UNITED STATES PATENT AND TRADEMARK OFFICE

APPLICATION NO.	FILING DATE	FIRST NAMED INVENTOR	ATTORNEY DOCKET NO.	CONFIRMATION NO.
10/759,920	01/16/2004	Shirley Wang	12283/13	1514
26646	7590	07/26/2004	EXAMINER	
KENYON & KENYON ONE BROADWAY NEW YORK, NY 10004			KATCHEVES, BASIL S	
			ART UNIT	PAPER NUMBER
			3635

Office Action Summary

DETAILED ACTION

Fig. 8

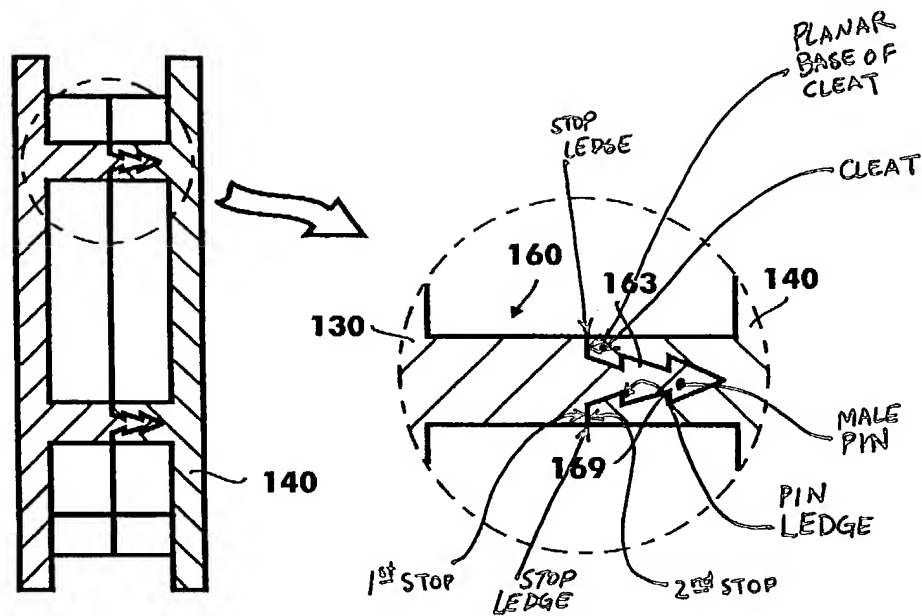
Regarding claim 13, Suh discloses a frame assembly (fig. 1: 100) for retaining a window (fig. 2: 120) in a door (fig. 1: 20) comprised of two frame members having screwless interlocks (fig. 8: 160 & 140). Suh discloses a first frame member (fig. 8: 160) and a second frame member (fig. 8: 140) having a stop (marked fig. 8) to prevent over insertion.

Regarding claim 14, Suh discloses the first interlock (fig. 8: 160) as being male and the second interlock (fig. 8: 140) as being female with a stop (marked fig. 8) which prevents over insertion.

Regarding claim 15, Suh discloses the stop as being part of the first interlock (marked fig. 8).

Regarding claim 16, Suh discloses the stop as being part of the second interlock (marked fig. 8).

Regarding claim 18, Suh discloses the stop (marked fig. 8) as being integrally formed as part of the first screwless interlock.

Regarding claim 20, Suh discloses the second screwless lock (fig. 8: 140) as having the stop (marked fig. 8) integrally formed.

Regarding claim 21, Suh discloses the first interlock as being a pin (fig. 8: 163) with extending ledges (marked fig. 8).

Regarding claim 22, Suh discloses the stop as having a ledge (marked fig. 8) which extends from the pin.

Regarding claim 23, Suh discloses the stop (marked fig. 8) as engaging an outer surface of the second interlock (marked fig. 8).

Regarding claim 24, Suh discloses an interlock comprised of a pair of pins (fig. 8: see left diagram with pair of pins).

Regarding claim 25, Suh discloses the stop as comprised from a pair of ledges (marked fig. 8) extending from the pins.

Regarding claim 26, Suh discloses the second interlock (fig. 8: 140) as having a pair of cleats (marked fig. 8).

Regarding claim 27, Suh discloses the interlocks as having two cleats (marked fig. 8).

Regarding claim 28, Suh discloses the stop as planar (marked fig. 8) and extending between bases of the cleats.

Regarding claim 30, Suh discloses the first interlock (fig. 8: 160) as integrally formed with the frame and includes a pair of pins (fig. 8: left diagram), each pin having a pair of horizontal ledges (marked fig. 8) extending from the pin. Suh also discloses a second interlock (fig. 8: 14) formed as part of the frame and having a double cleat (marked fig. 8) with a planar base extending between cleats (marked fig. 8).

Regarding claim 32, Suh discloses the first interlock (fig. 8: 160) as integrally formed with the frame and includes a pair of pins (fig. 8: left diagram), each pin having a pair of horizontal ledges (marked fig. 8) extending from the pin. Suh also discloses a second interlock (fig. 8: 14) formed as part of the frame and having a double cleat (marked fig. 8) with a planar base extending between cleats (marked fig. 8).

Regarding claim 34, Suh discloses the first interlock (fig. 8: 160) as integrally formed with the frame and includes a pair of pins (fig. 8: left diagram), each pin having a pair of horizontal ledges (marked fig. 8) extending from the pin. Suh also discloses a second interlock (fig. 8: 14) formed as part of the frame and having a double cleat (marked fig. 8) with a planar base extending between cleats (marked fig. 8).
